# New Product Bulletin

## Door System Check Valve

10305-087

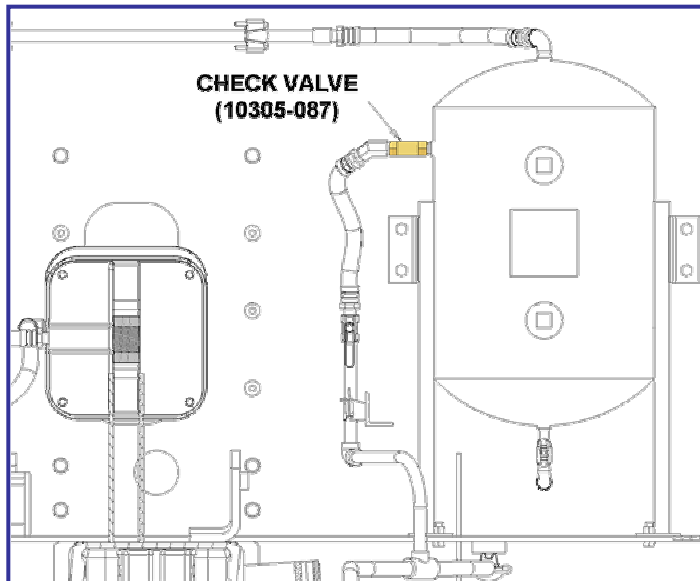
Our new standard check valve, part number 10305-087, is just one example. The Teflon seal and brass construction are less susceptible to sticking when exposed to wet, dirty air. We have also found that by installing the check valve horizontally, there is less accumulated dirt and debris build up in the valve.
